Performance Bulletin

October 2007

Motor Drive Assembly Changes

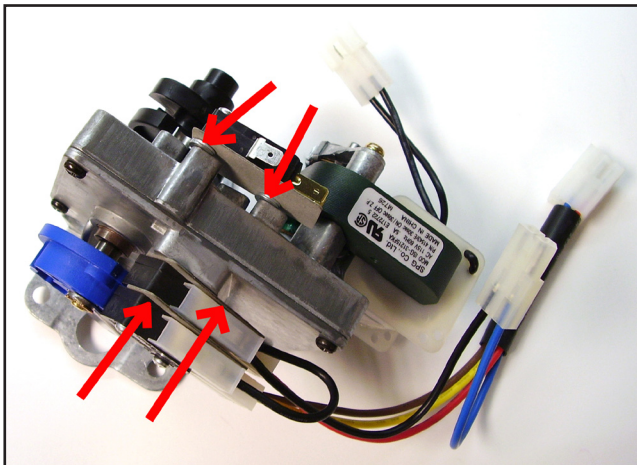
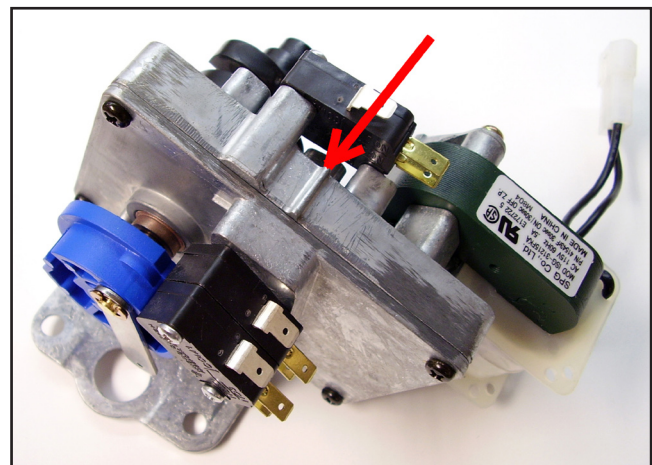
Effective immediately as a running change as inventory depletes, there will be changes to the look of three motor drive assemblies. The switch insulators and the spacer washers on the auxiliary switch will be removed. The gear case has higher bosses for mounting the switches to accomplish this change. The motor gear case with this change has an identification boss on top. Existing product in the field should be used with the insulators and spacer washers to achieve good alignment of the switch on the cam. If a new motor in the field is accidentally used with insulators and spacer washers, the switches will still function. The assembly numbers will remain the same.

Old Motor with Microswitch Insulators & Spacer Washers
(see red arrows)

New Motor without Microswitch Insulators & Spacer Washers
(red arrow shows new identifying mark)
